Invitation To Bid: IFB-02-ENG-2019
Upgrade of the Northern District Wastewater Treatment Plant
GWA Project No. S17-003-OEA

Addendum No.: 06

Date: May 8, 2019

Response No. 9 to Step 2 Contractor Inquiries

9 GUARDRAIL DET "E"
1" = 1'-0"

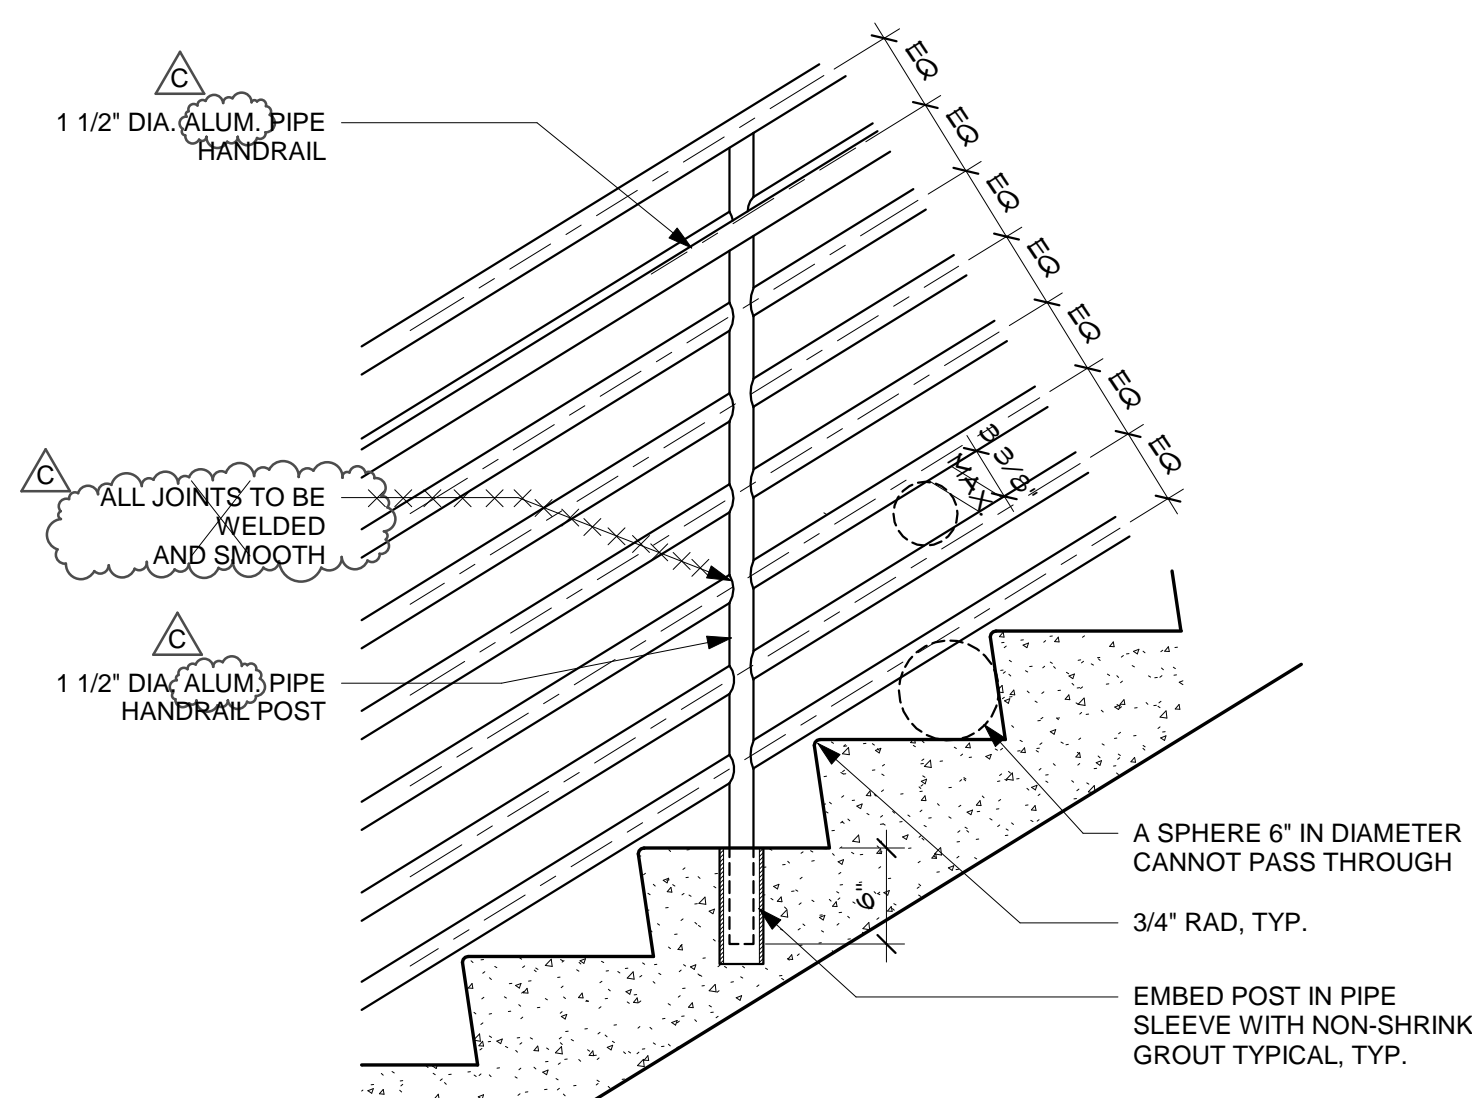
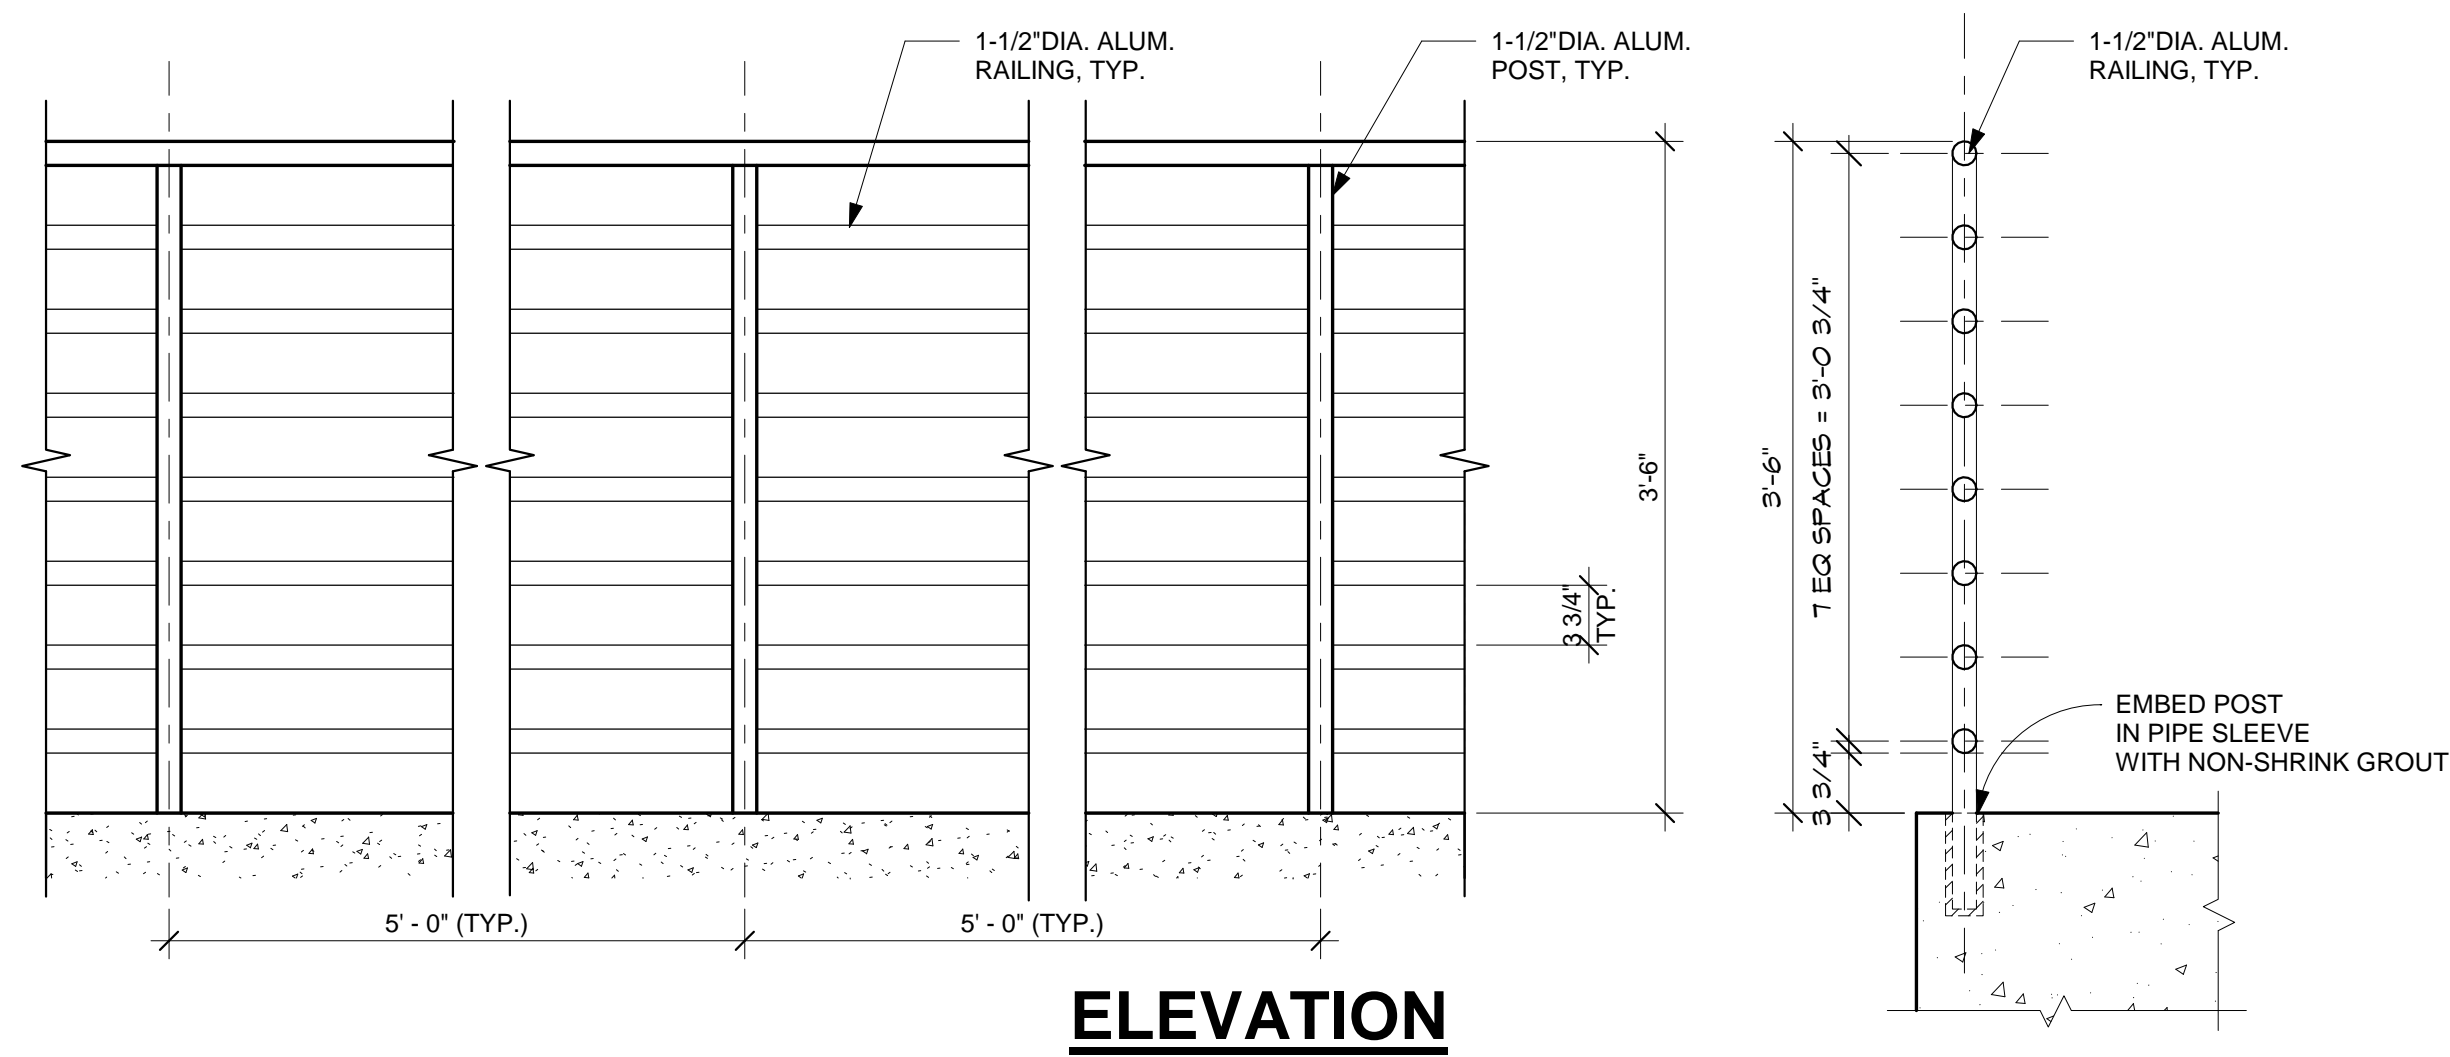
30i	Sheet A0.7	Please confirm that all railings and handrailing are to be made of aluminum as per Railing Details on sheet A0.7.	All handrails and railings are aluminum. See attached drawings A0.7.

32a	Sheet A0.7 and Section 055823	Details 5, 6, 7, & 9 on A0.7 indicate welded aluminum railings ("all joints to be welded and grind smooth") whereas aluminum railing spec 055823, 2.3, B provides for non-welded rail connections. 3.3, F also indicates "mechanical or adhesive joiner method and fittings." Please clarify that the railings are to be welded connection.	Refer to answered Item 30i.
32b	Aluminum Handrail	Bidder Question 20d on Response 7 indicated the railing finish to be siliconized powder coating. Please confirm if AAMA 2603, 2604, or 2605 criteria. Also, will primer coat be required?	Aluminum Railing is a clear anodized finished.
